TECHNICAL SERVICE BULLETIN

Number: TSB-FC-2020-016

Model & Symptom: SC50 to stay on indefinitely, drained battery.

FIELD CORRECTIVE ACTIONS:

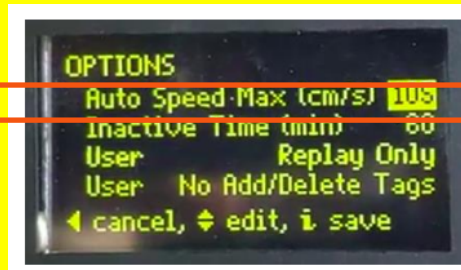
Only for Liberty SC50 with control panel (AKA Main Machine Controller, MMC) firmware version 4.01 and autonomy module firmware version 9.0.0.

There is a bug that allows the machine to stay on indefinitely, unattended, if the user interrupts the power while charging the machine with no key. The machine will go into a "key request" state that boots up the autonomy and MMC. The SC50 may stay this way until the battery dies.

Firmware bug present in MMC firmware version 4.01 and autonomy module firmware version 9.0.0.

Use the update process described in the June revision of the Service Manual (page 119) to update both the autonomy and MMC to the minimum required version of:

CRL Compute - 9.1.2+b593

MMC - 4.05.

VERY IMPORTANT: after the update is complete:

1. Go into the "OPTIONS" menu by pressing "i" button, then select "OPTIONS".
2. Once in the menu, change the "Auto Speed Max" to 105, then press "i" to save.
